Access Compliance Report

(Curb Ramps)

Intersection ID: 28282	Main Street: ARVIND_OAKS_CT	Cross Street: OLD_ARDREY_KELL_RD	Location: NW
ADA ID: 3D6540FB6413	Ramp Type: PerpDiag	Initial Pass/Fail: Fail	Overall Compliance: No
Severity Score: 8.75			
Codes/Mitigation Info/Possible Solution		Field Measurements/Component Compliance

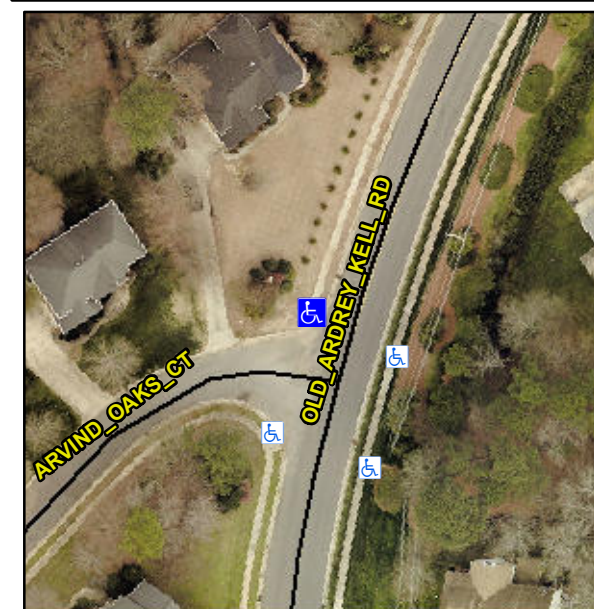
Not Found, R304.5.1

Compliance	Description	Data	Compliance	Description	Data
N/A	Ramp Length (in)	48.0	Yes	Ramp Slope (%)	8.2
No	Ramp Width (in)	40.0	Yes	Ramp XSlope (%)	1.9
N/A	Flare Type LT	N/A	N/A	Flare Type RT	N/A
N/A	Flare Slope LT (%)	N/A	N/A	Flare Slope RT (%)	N/A
N/A	Flare Traversable LT?	N/A	N/A	Flare Traversable RT?	N/A
N/A	Landing Length (in)	N/A	N/A	DWS Provided?	N/A
N/A	Landing Width (in)	N/A	N/A	DWS Contrast?	N/A
N/A	Landing Slope (%)	N/A	N/A	DWS Length (in)	N/A
N/A	Landing X Slope (%)	N/A	N/A	DWS Full Width?	N/A
N/A	Landing Curb? (Y/N)	N/A	N/A	DWS Offset (in)	N/A
N/A	Shared Landing?	N/A			
N/A	Gutter Ponding?	N/A	N/A	Gutter Slope (%)	N/A
N/A	Gutter Lip Ht (in)	N/A	N/A	Gutter X Slope (%)	N/A
N/A	Painted X Walk1?	No	N/A	Painted X Walk2?	No
	X Walk 1 Direction	To SW		X Walk 2 Direction	To SE
N/A	X Walk 1 Width (in)	N/A	N/A	X Walk 2 Width (in)	N/A
	X Walk 1 Slope (%)	0.3		X Walk 2 Slope (%)	6.6
	X Walk 1 X Slope (%)	0.0		X Walk 2 X Slope (%)	0.2

Remove & Replace Curb Ramp With Two New Directional Ramps or Equivalent.
